Value Engineering: Final Report- Bear River Migratory Bird Refuge Headquarters and Education Complex

Value Engineering

Bear River Migratory Bird Refuge Headquarters and
Education Complex - FWS

December 26, 2000

Figure 3. Switch Parking and Maintenance

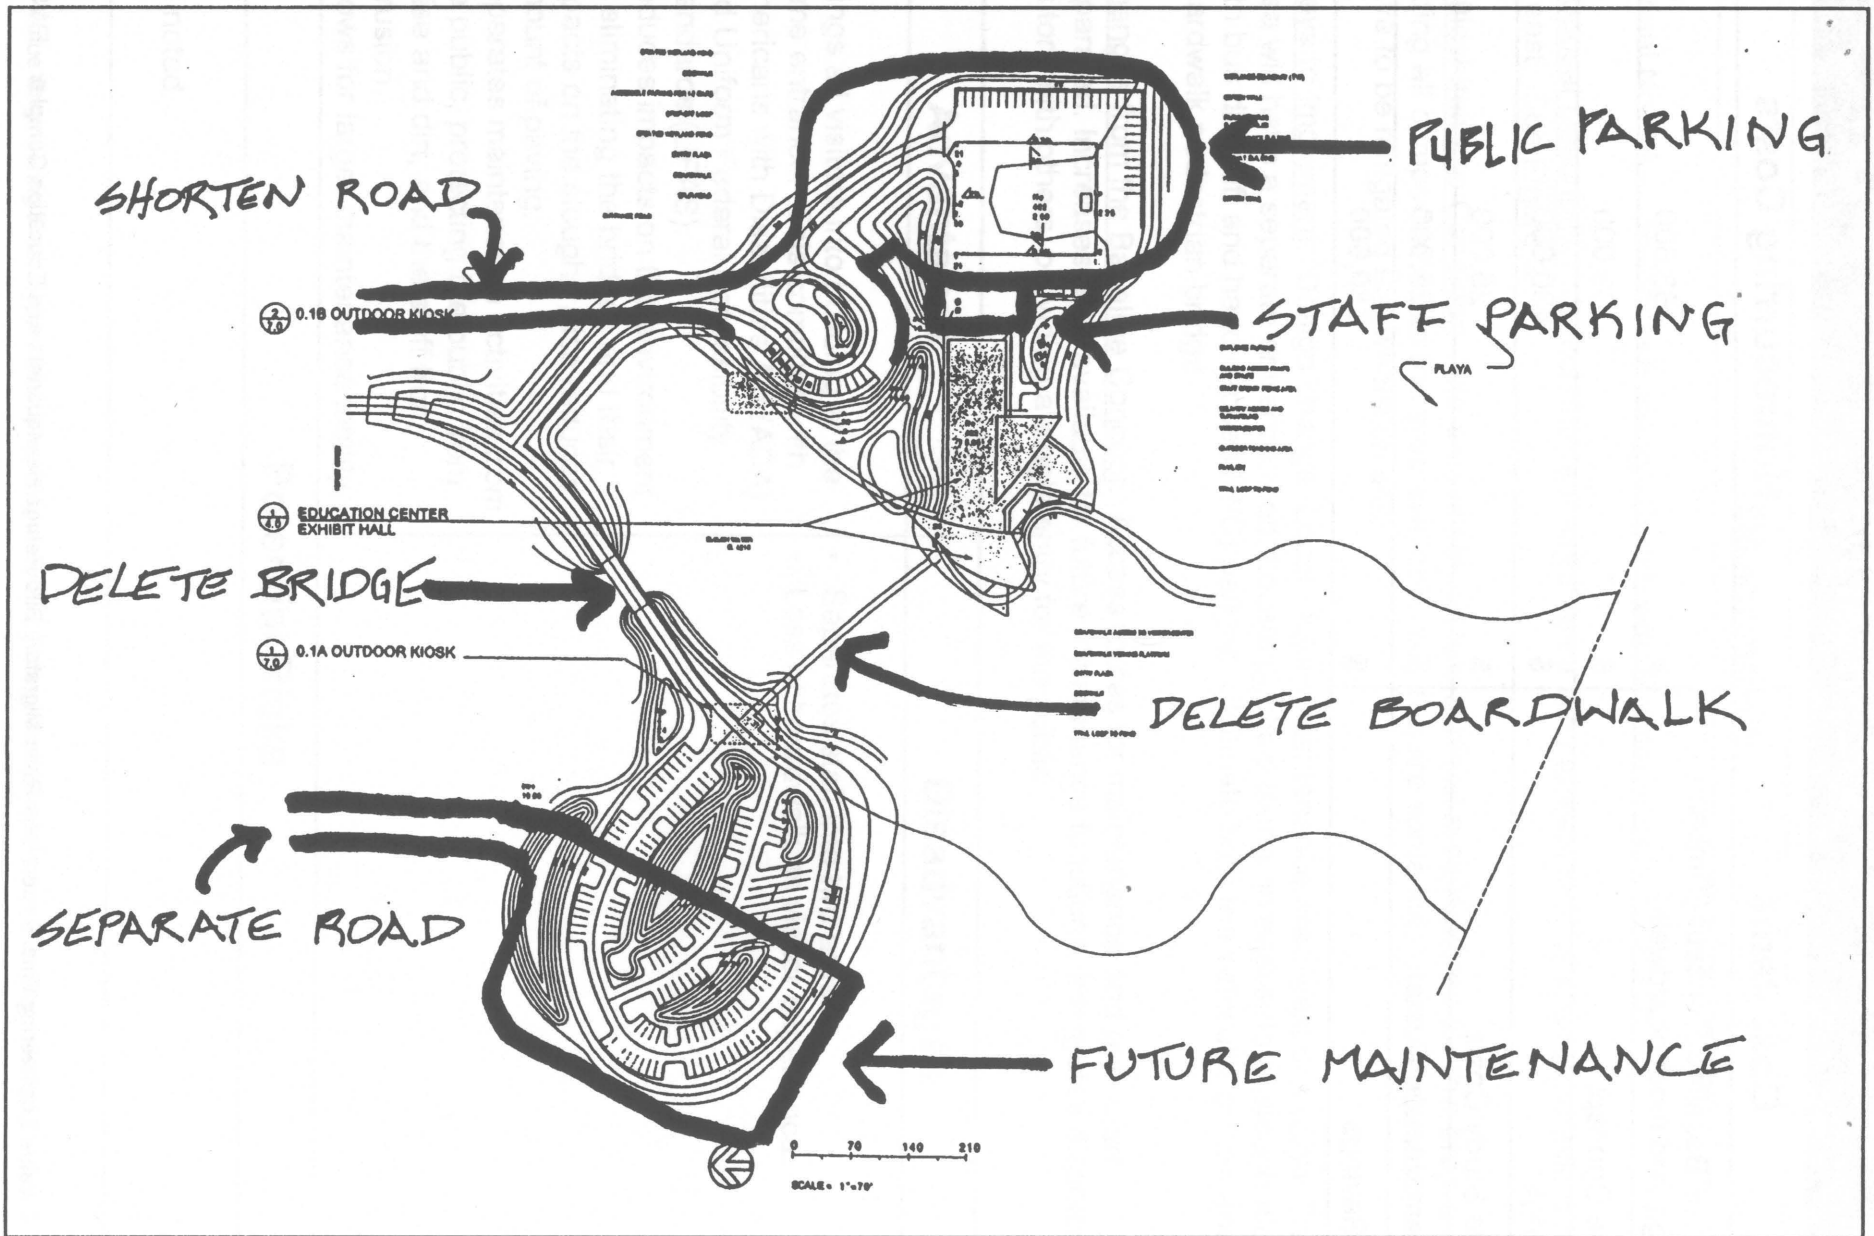
- Proposal Description: Switch future maintenance area to west side of site and public parking to east. See Figure 3.
- Critical Items to Consider: Site east of slough has minimal area required for this program. Fitting all components into the area available may require some loss of wetlands which would have to be mitigated elsewhere on site.
- Ways to Implement: Design change. Locate future maintenance area west of slough. This area will have a separate entrance road. Locate public parking on east side of slough along with bus drop off and handicapped (H/C) parking. Eliminate both the vehicular bridge and the boardwalk pedestrian bridge.
- Changes from the Baseline Concept: Access routes for maintenance and public are separated. Increases area available for future maintenance functions. Integrates disabled visitors with others, providing a single entry for the public.

Figure 5. Typical Road Section, Unsurfaced

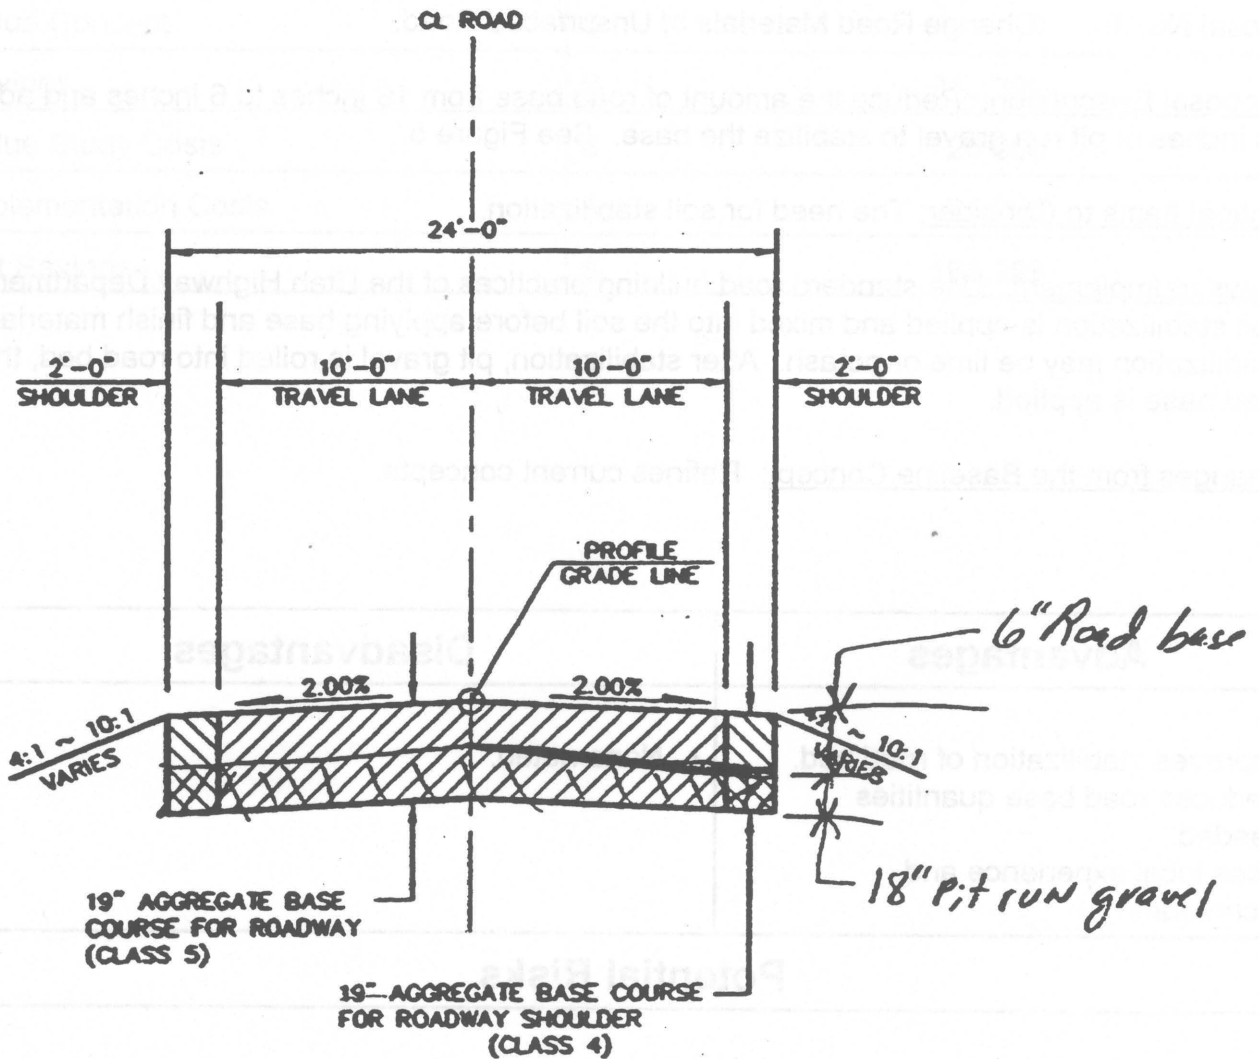
- Proposal Description: Reduce the amount of road base from 19 inches to 6 inches and add 18 inches of pit run gravel to stabilize the base. See Figure 5.
- Critical Items to Consider: The need for soil stabilization.
- Ways to Implement: Use standard road building practices of the Utah Highway Department. Soil stabilization is applied and mixed into the soil before applying base and finish materials. Stabilization may be lime or potash. After stabilization, pit gravel is rolled into road bed, then road base is applied.
- Changes from the Baseline Concept: Refines current concepts.

Figure 6. Typical Road Section, Surfaced

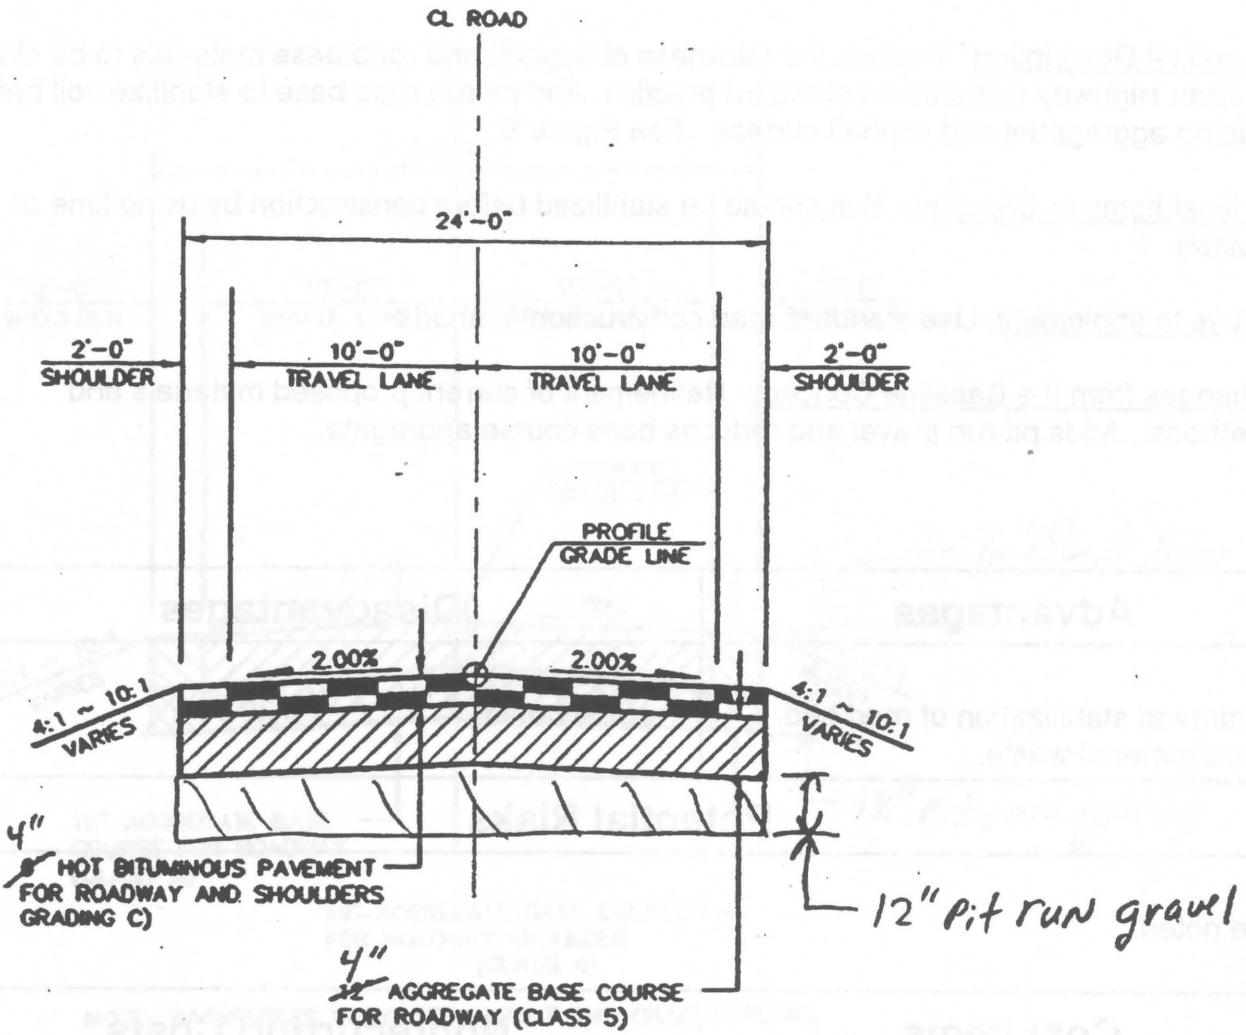
- Proposal Description: Reduce the thickness of asphalt and road base materials to be closer to Utah Highway Department standard practice. Add pit run road base to stabilize soil before adding aggregates and asphalt surface. See Figure 6.
- Critical Items to Consider: Soil should be stabilized before construction by using lime or potash.
- Ways to Implement: Use standard road construction methods.
- Changes from the Baseline Concept: Refinement of current proposed materials and methods. Adds pit run gravel and reduces base course aggregate.

Figure 7. Geof foam Foundation - Partially Compensated

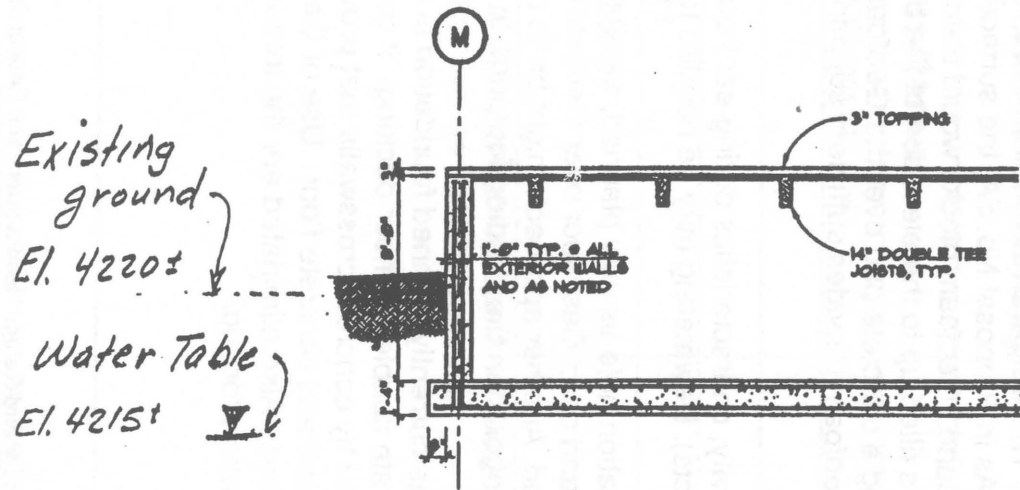
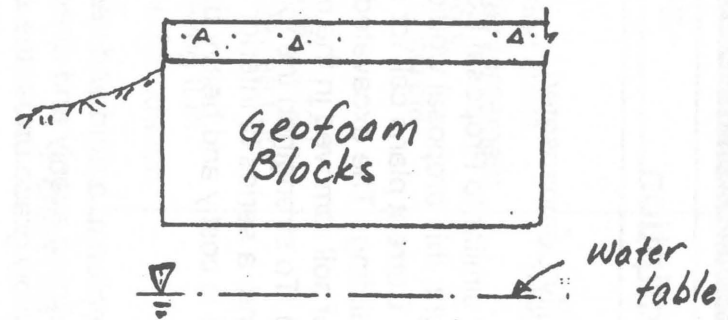
- **Proposal Description:** Current plans call for supporting the building with a basement 8 feet deep under the entire building. The excavated hole will be about 5 feet below existing grade, displacing soil (the weight of soil removed in the excavation partially compensates for the weight of the building). To strengthen the foundation and provide support for concrete double tee floor decking, a series of interior concrete crosswalls are planned. This design is strong; however, it is costly and heavy due to the large amount of concrete needed. The current design does not include dewatering, which may be needed. To be consistent, this proposal does not include dewatering. See Figure 7.

- This proposal partially compensates for the building weight as does the current design. It supports the building with Geofoam, a rigid and very lightweight foam product capable of transferring the weight of the building evenly and directly to the ground surface. A 3-foot-deep hole would be excavated below grade under the entire building (excluding the basement area below the mechanical room, where a concrete foundation would be constructed similar to the current design). The surface of the excavation would then receive a leveling blanket of sand fill. Geofoam blocks would then be layered in successive lifts until the interior of the foundation is filled up to the elevation of the bottom of the floor. The floor would be constructed by pouring a concrete pad upon the Geofoam. No interior support walls are needed because the Geofoam provides sufficient support to carry all the weight.

- **Ways to Implement:** Excavate the foundation hole as now planned, except 2 feet shallower. Place Geofoam instead of concrete walls and pad. Cast floor over Geofoam instead of concrete double tee sections now planned.

Figure 8. Geofom Foundation - Fully Compensated

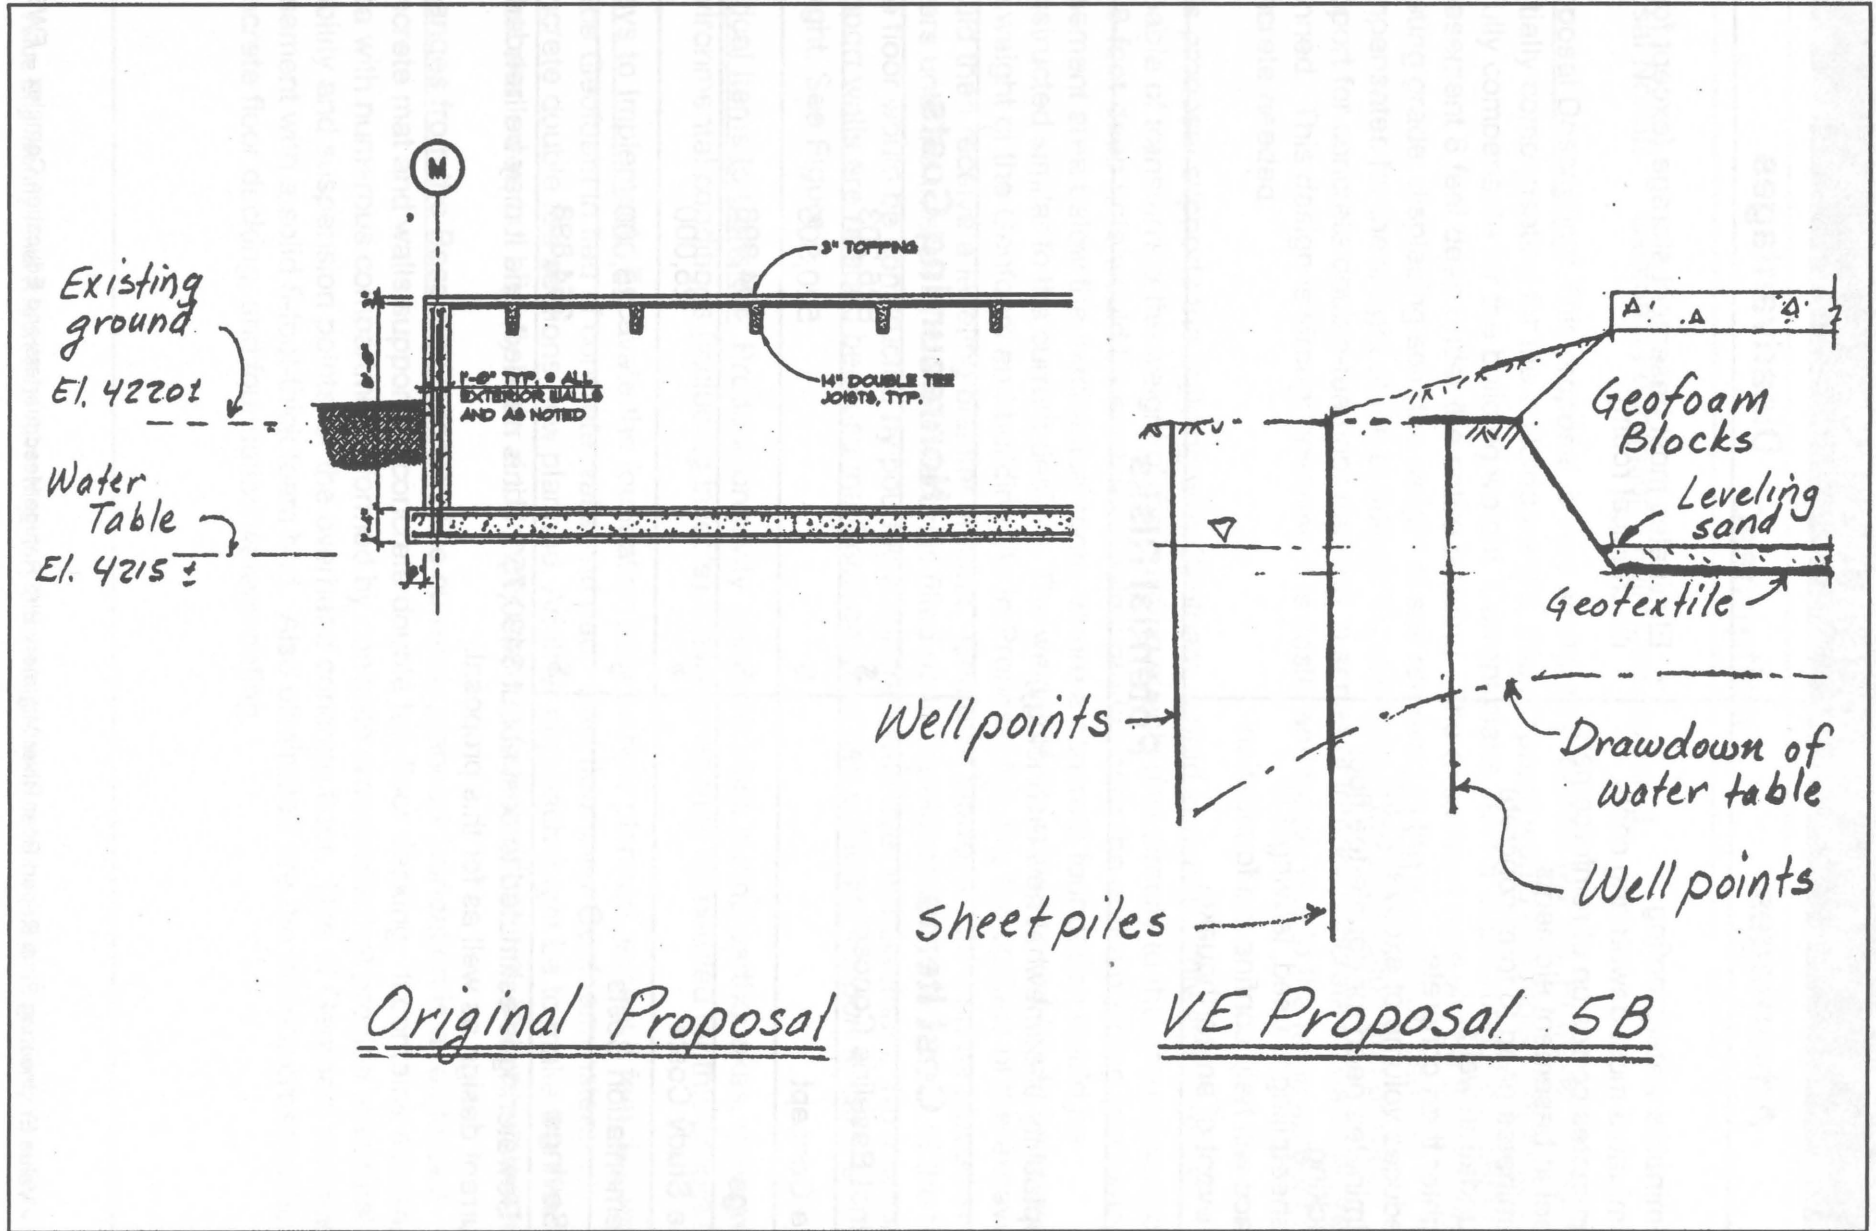
- **Proposal Description:** This proposal is very similar to Proposal No. 5A. However, instead of partially compensating for the building weight, this proposal would use more light weight foam to fully compensate for the building weight. Current plans call for supporting the building with a basement 8 feet deep under the entire building. The excavated hole will be 5 feet below existing grade, displacing soil (the weight of soil removed in the excavation partially compensates for the weight of the building). To strengthen the foundation and provide support for concrete double-tee floor decking, a series of interior concrete crosswalls are planned. This design is strong; however, it is costly and heavy due to the large amount of concrete needed.

- This proposal supports the building with Geofoam, a rigid and very lightweight product capable of transferring the weight of the building evenly and directly to the ground surface. An 8-foot-deep hole would be excavated below grade under the entire building (excluding the basement area below the mechanical room, where a concrete foundation would be constructed similar to the current design). The weight of the soil removed would be equal to the weight of the Geofoam and building. As in Proposal No. 5A, the surface of the excavation would then receive a leveling blanket of sand. Geofoam blocks would then be placed in layers until the interior of the foundation is filled up to the elevation of the bottom of the floor. The floor would be constructed by pouring a concrete pad over the Geofoam. No interior support walls are needed because the Geofoam provides sufficient support to carry all the weight. See Figure 8.

- **Ways to Implement:** Excavate the foundation hole as now planned, except 3 feet deeper. Place Geofoam in lieu of concrete walls and pad. Cast floor over Geofoam instead of concrete double tee sections now planned. Another approach might be to make the Geofoam block shallower, but slightly wider and longer than the building footprint, to avoid dewatering.
